Cricklade Town Council's Planning, Conservation and Transport Committee 20TH October 2025

PL/2023/10331

Site: Land south of The Forty and north of Chelworth Rd, Cricklade
Proposal: Outline Planning application (with all matters except access reserved) for up to 49 dwellings & associated works and provision of a cemetery together with access and associated works.
Applicant: **Hannick Homes and Developments Ltd**
Closing Date: 13/10/25 - **Extension Granted to 21/10/25**

5a Revised Site Layout – overall – Plan was shown

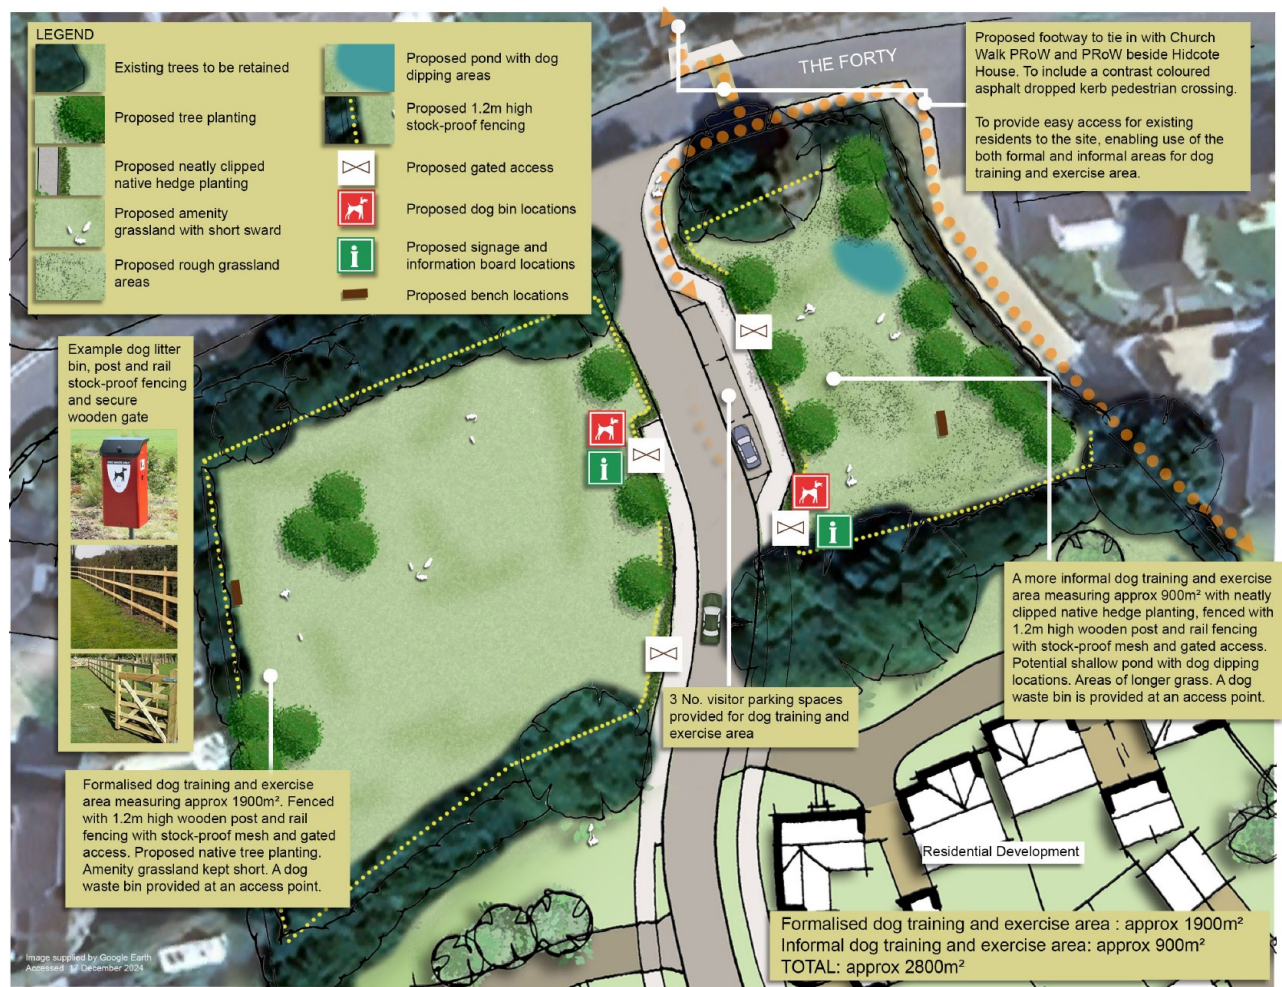
The layout has changed slightly with the houses in the southernmost section now relocated.

The intention is to have fenced areas enabling dogs to be exercised off the lead. Three visitor parking is provided. The objective is to provide a safe dog walking area so that recreational pressure on North Meadow is alleviated. However, it is impossible to quantify the benefit of such a facility, North Meadow is just over 1km from the site and it is not known how many dog owners would walk that far to exercise their dogs.

However, the drawbacks are clear, there are a number of commercial dog walking fields around Cricklade and the provision of a free alternative might encourage usage of this facility from elsewhere thus bringing more traffic to the road and possible conflict with other dog owners when using it at the same time. Further,

there are potential noise issues causing a loss of amenity both to residents of the new development and also neighbouring residents of The Forty, Chelworth Road and Deansfield. The commercial dog walking fields mentioned above are all sited in open countryside, well away from residential areas.

- 6) The junction of the new development with The Forty has poor visibility for vehicles.
- 7) The proposed dog area is too small to be of practical use and will become very muddy in wet weather.

- 8) The proposed dog area is a worthwhile buffer between the new development and The Forty but would be better used as a nature reserve.
- 9) The application was deficient in several respects when judged against National Planning Policy Framework (NPPF) requirements - especially with respect to the infrastructure proposals and, in particular, paragraphs:

- 3. State that the concept of the Dog Area is not appropriate in this location, the area of open space could be much better used as a wildlife area (possibly with pond), community orchard, children's play area etc.
